Model: MET-C2cde	Date: 13-May-16	No.: RD242006
-------------------------	-----------------	---------------

Subject: Firmware Release Note: PowerSaving Sys		Prepared by: M. Kumagai	
From: 1st Tech Service Sect., MFP/Printer Tech Service Dept.			
Classification:	<input type="checkbox"/> Troubleshooting	<input type="checkbox"/> Part information	<input type="checkbox"/> Action required
	<input type="checkbox"/> Mechanical	<input type="checkbox"/> Electrical	<input type="checkbox"/> Service manual revision
	<input type="checkbox"/> Paper path	<input type="checkbox"/> Transmit/receive	<input type="checkbox"/> Retrofit information
	<input type="checkbox"/> Product Safety	<input checked="" type="checkbox"/> Other (Firmware)	<input checked="" type="checkbox"/> Tier 2

This RTB has been issued to announce the firmware release information for the **PowerSaving Sys.**

Important Notice

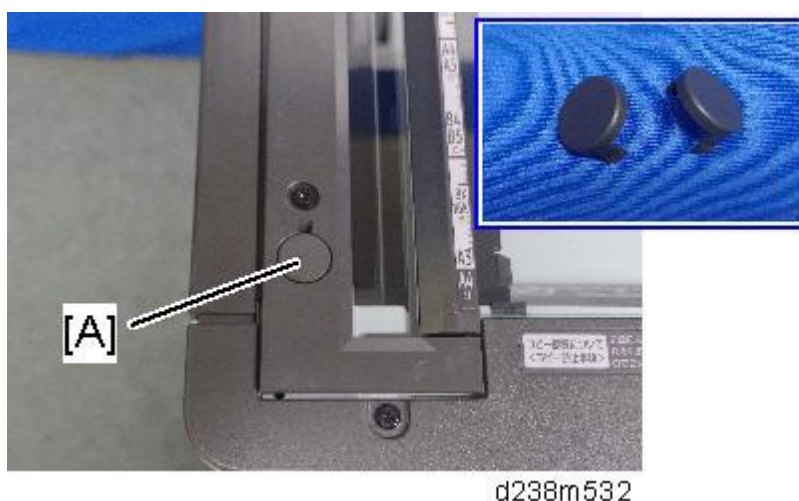
- On machines produced from the cut-in S/N listed below, the cap covers for the scanner are now located inside a small plastic bag affixed to the area shown below.
- Make sure to **attach the caps** to the holes [A] shown below, as mentioned in the Service Manual. If these caps are not used, dust can get inside the holes in the scanner plate.

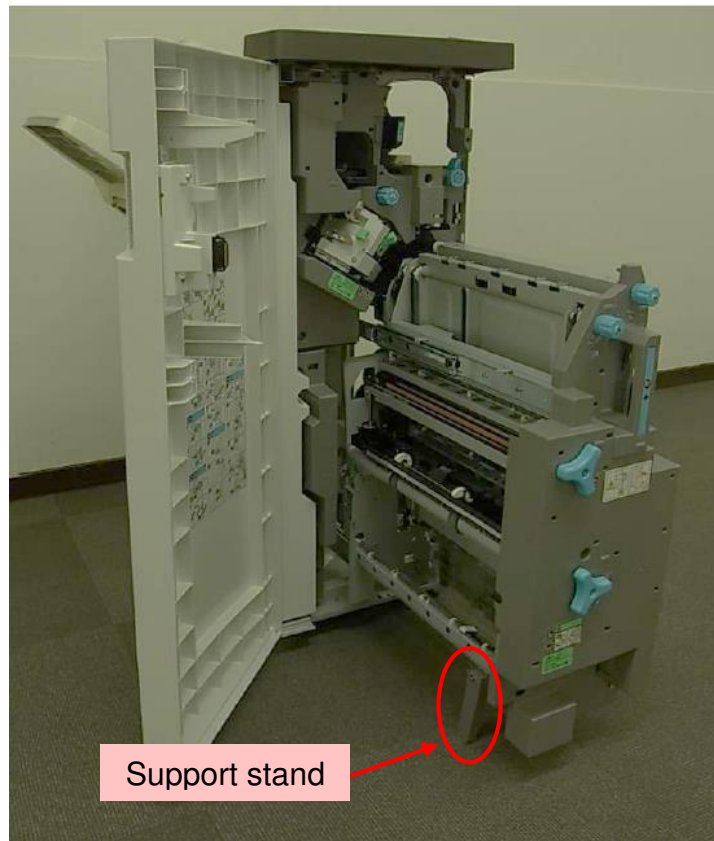
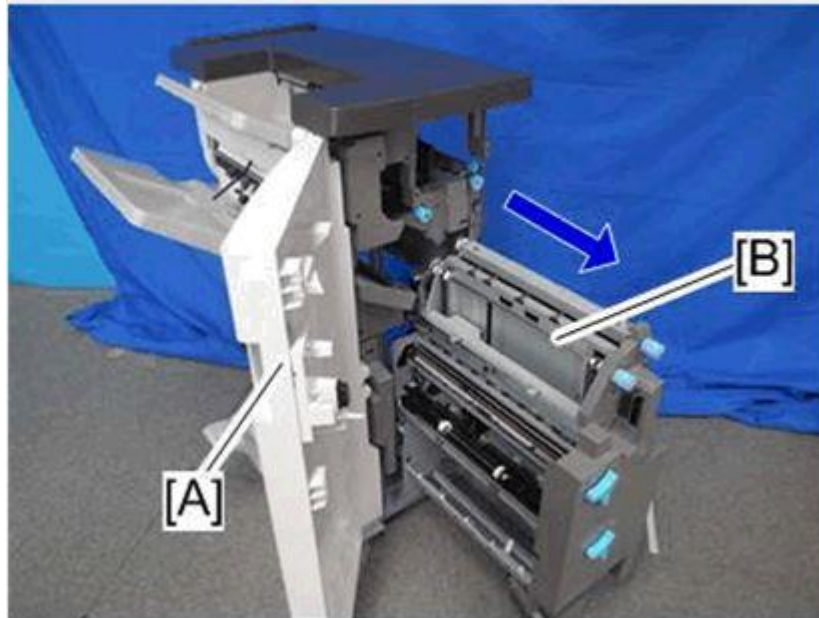
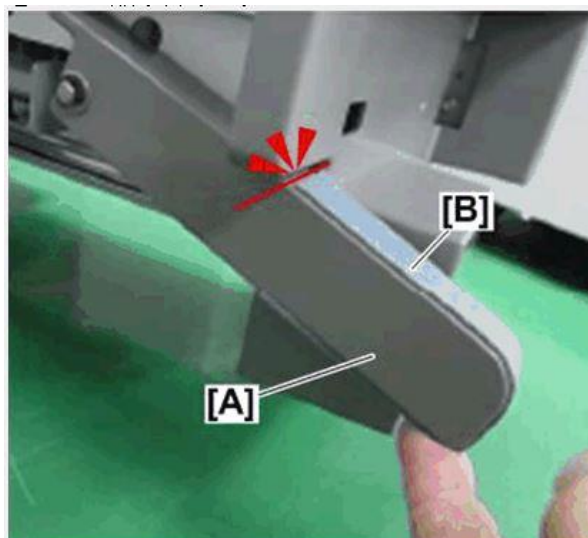
Add the following information about the installation of the Booklet Finisher SR3240.

When installing the **Booklet Finisher SR3240** on a fragile surface (e.g., any kind of coated, metallic, tile, stone, or wooden floor or flooring), make sure to **attach a cushion sheet to the bottom of the support stands** of the saddle stitch unit.

This is to avoid damaging the surface on which the finisher is installed, which can happen when the saddle stitch unit is opened. When the unit is opened, the edge of the support stand can sometimes scratch the installation surface.

1. Open the Front Cover [A] and pull out the Saddle Stitch Unit [B].

2. Lift up the Support Stand [A] of the Saddle Stitch Unit, and push against the upper part. Then, attach the Cushion Sheet [B] while aligning the edge with the upper part.

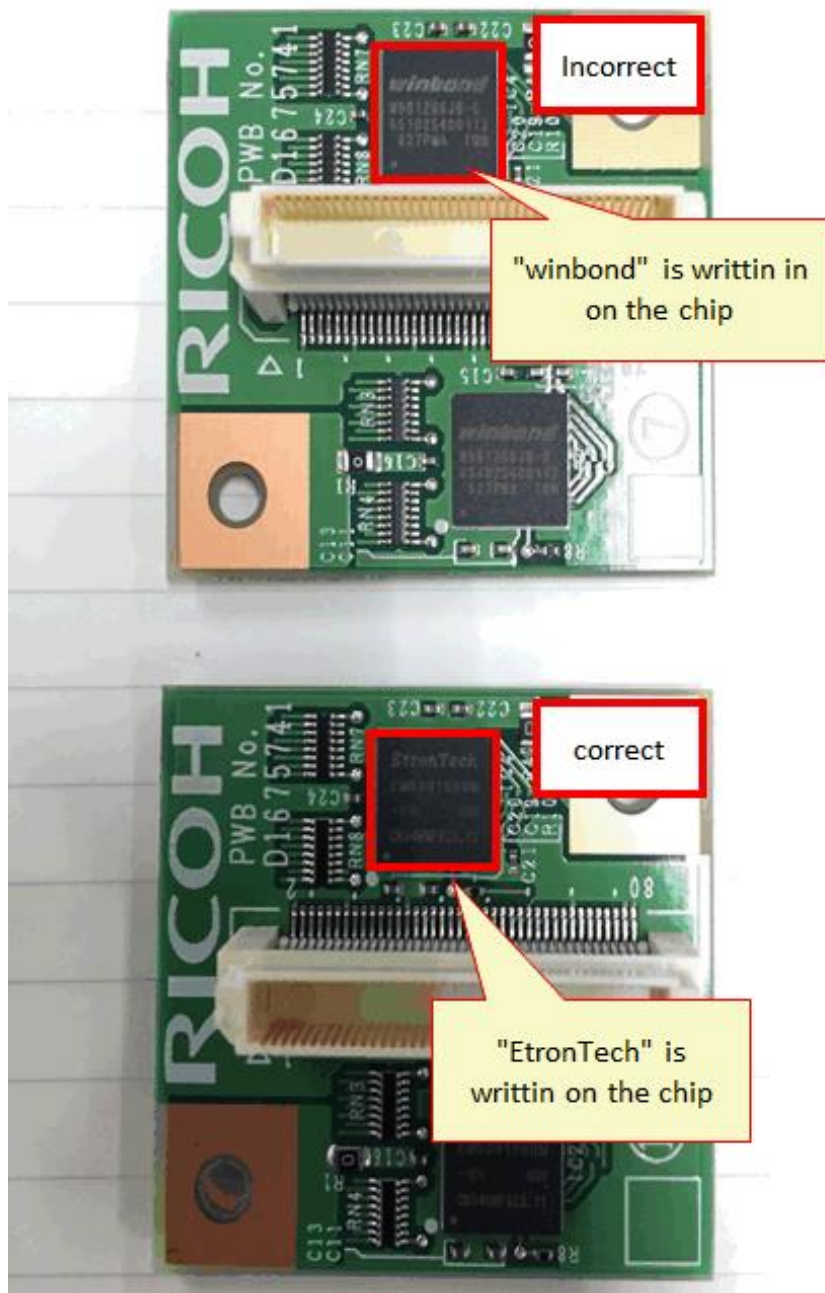
- Changed the value of the resistance on the Fax Memory Unit
- Changed to a different manufacturer of memory modules for the Fax Memory Unit
- The modification has been applied at the factory at Sep 2016.

How to identify if they are affected or not is the text on the chip on the Fax memory board, as shown in the photos below.

- Incorrect (affected) is the chip with "winbond" written on it.
- Correct (not affected) is the chip with "EtronTech" written on it.

Replace the Fax Memory Unit with the modified one.

Fig.1

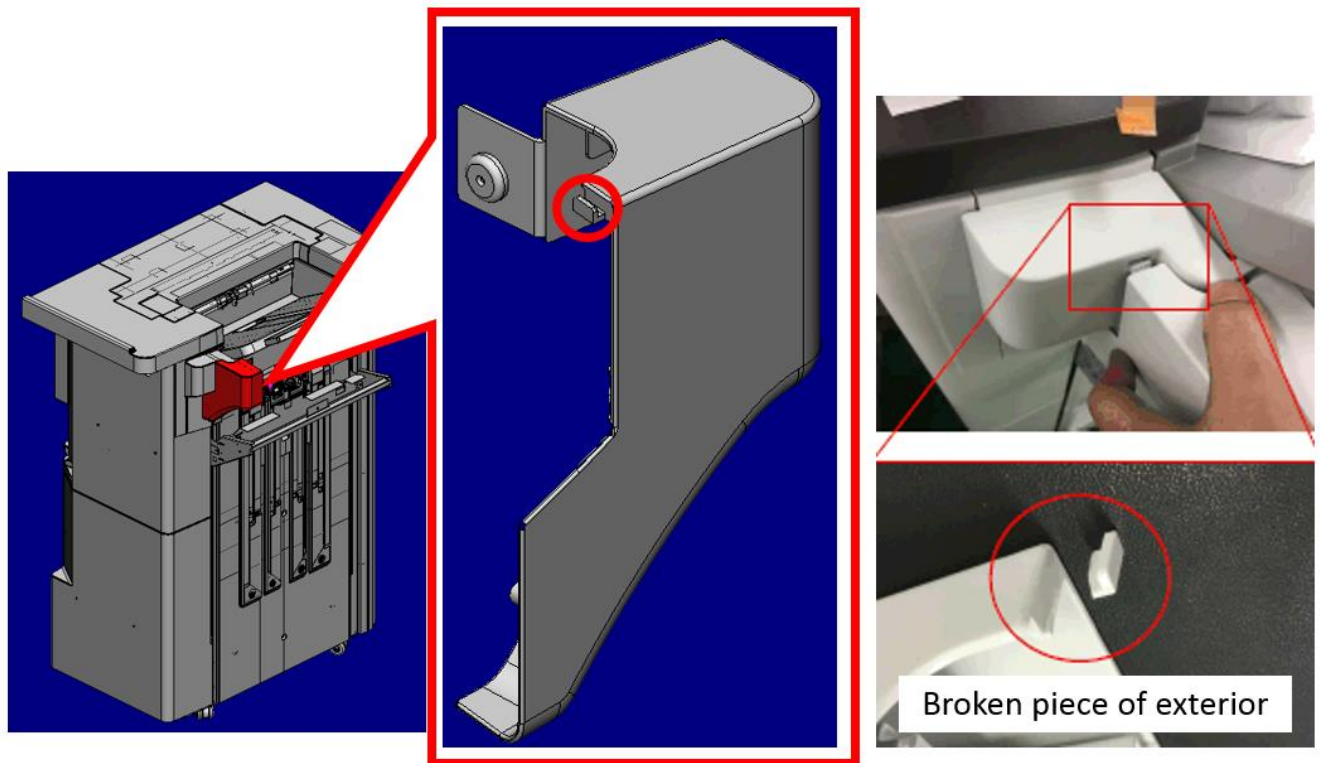
This prevents the paper guide from returning to the home position.

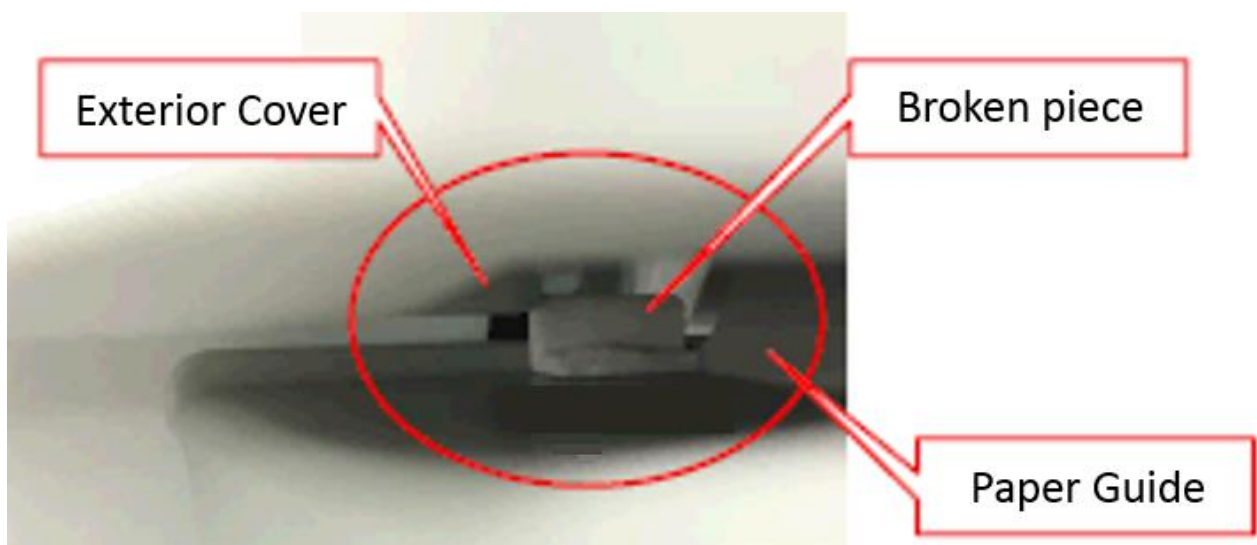
Check the clearance between the paper guide (GUIDE: PAPER: REAR: ASS'Y) and the exterior cover (COVER: PAPER: GUIDE) to see if there is a broken piece.

Figure1 right rear cover

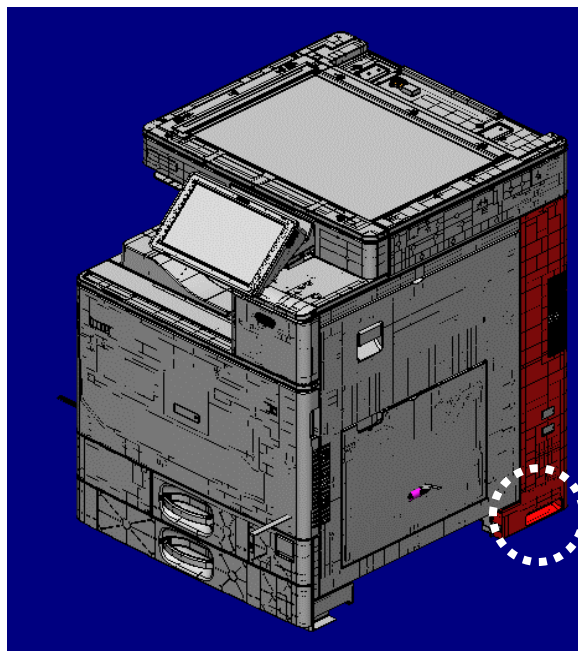
- Make sure to do the following when installing the machine:
 Hold the grip of the right rear cover as shown in **Fig. 2 (CORRECT)**.
 Insert your fingers **all the way up and inside the grip**.
- If you do not, the right cover will break, as shown in Fig. 4.

Overview

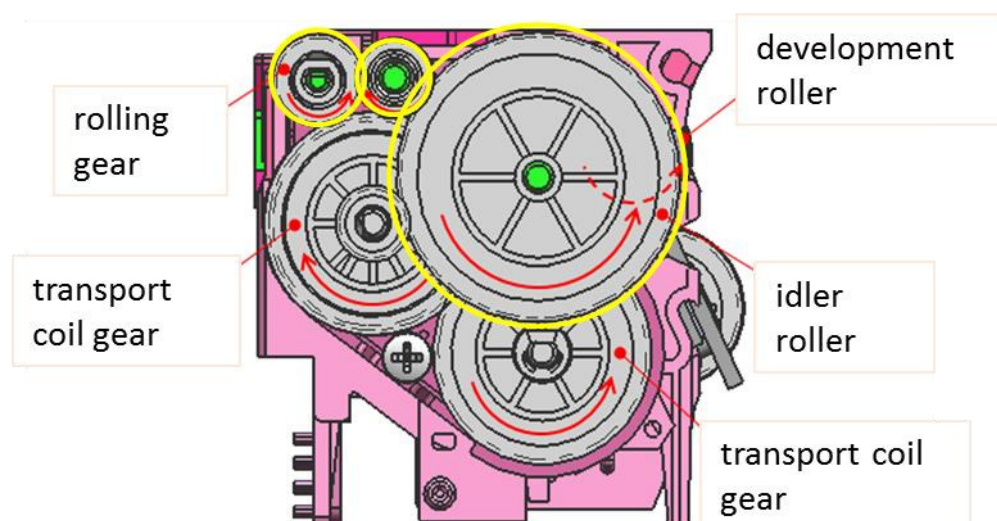
Three new gears (yellow circles) are added. They are driven from the developer collection coil gear, so the seal is automatically wound. This mechanism works at installation and/or replacement.

Before the modification, PCDU covers were included separately in the machine's carton box.

After the modification, the PCDU covers are already attached to the machine.

Figure.1

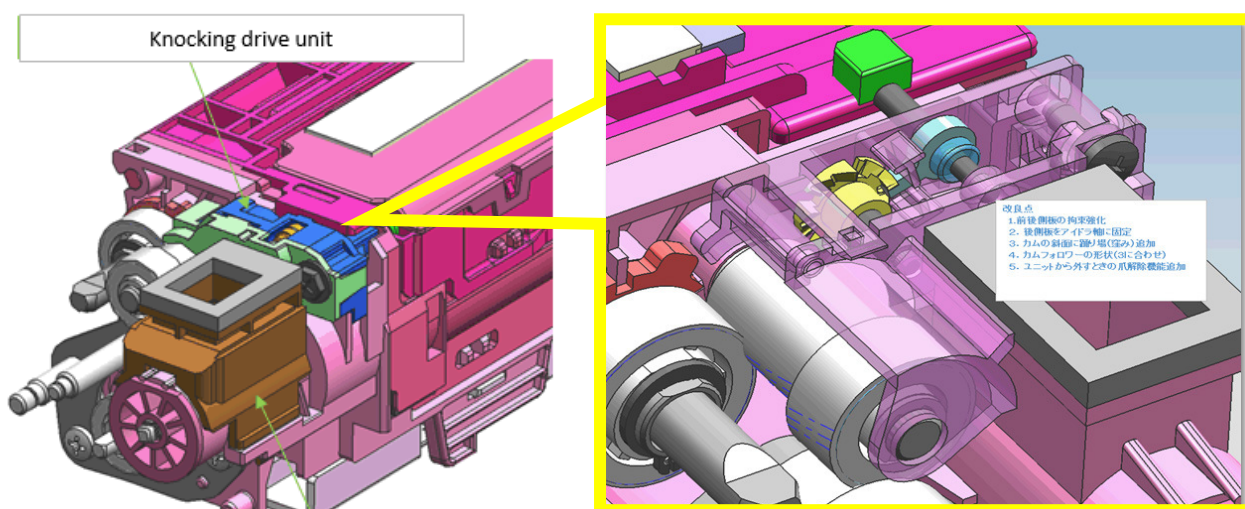
A new knocking mechanism has been added (Fig.1). Normally, the air flows from the development roller to the filter in the development unit (Fig. 2). However, when the filter is full of toner, the inner pressure increases and reverse air flow occurs, which causes toner blasting to occur (Fig.3). To prevent this, the knocking mechanism periodically knocks the development unit cover, so toner in the filter drops back into the development unit. This mechanism works by reverse rotation of the development roller.

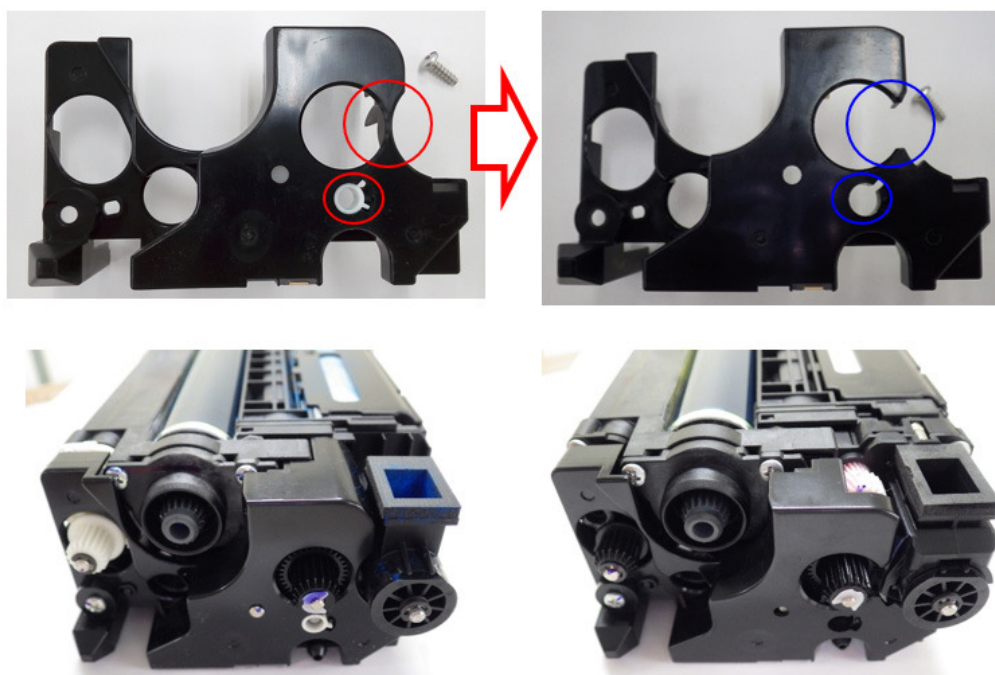
The duct cover is included to the new development unit and PCDU. Please replace together when you replace development unit or PCDU. Note: It is not necessary to use the white bearing of the old duct cover in the new duct cover.

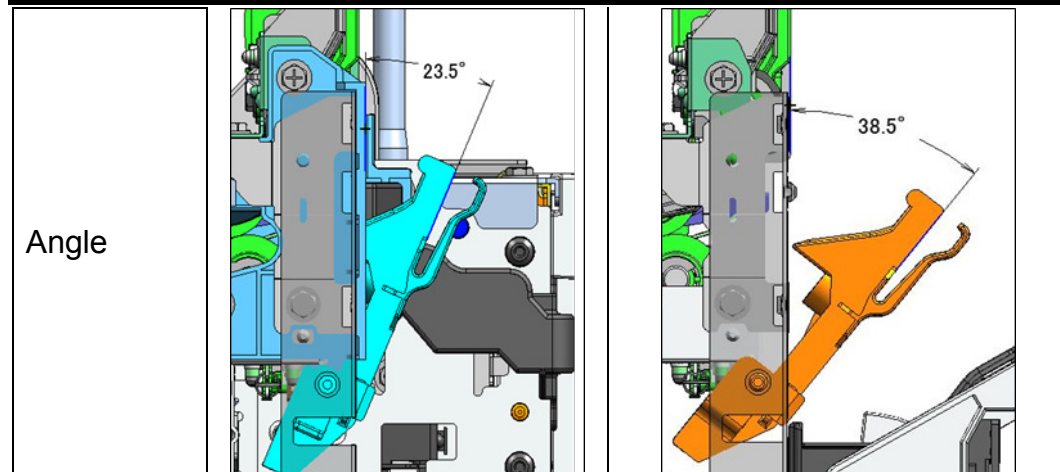
Change: The shape of the guide plate was changed.

1. Release the hook and remove the guide plate.

2. Attach the guide plate by sliding it toward the right hole.

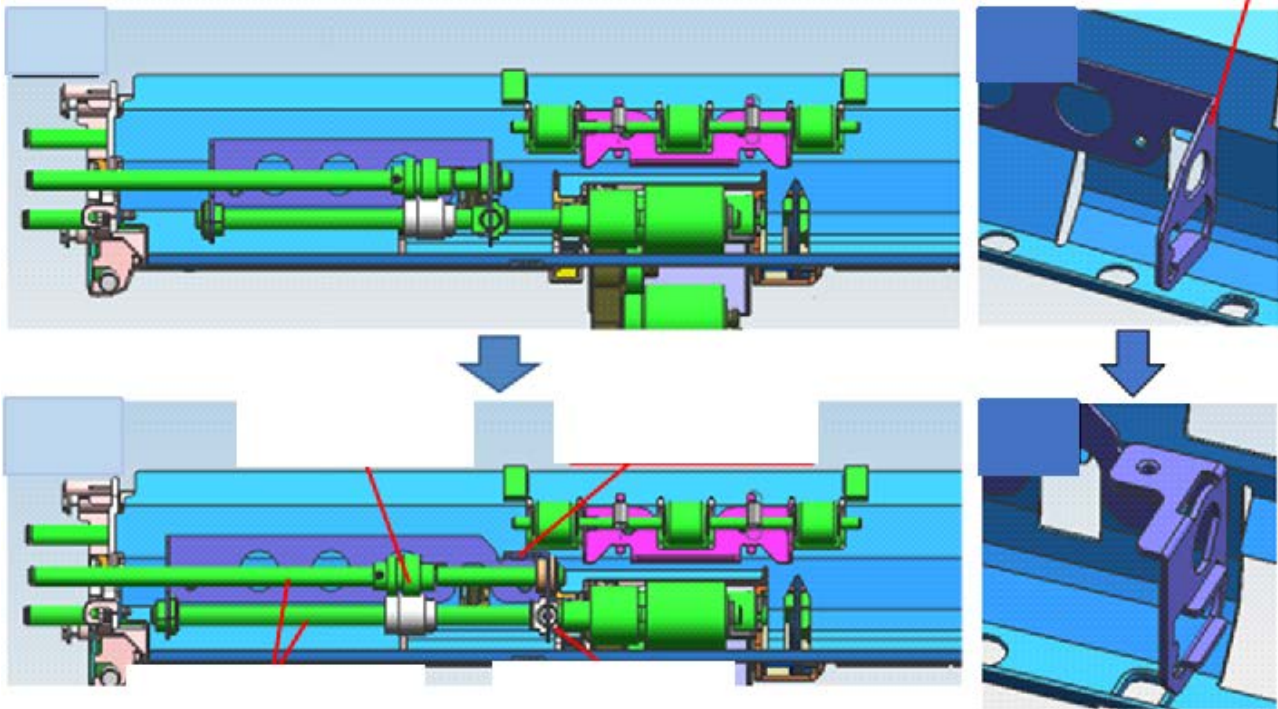
Change 4: There are no protruding parts to hold the gear. An e-ring added to stop the gear in position, and a groove added to the shaft for the e-ring.
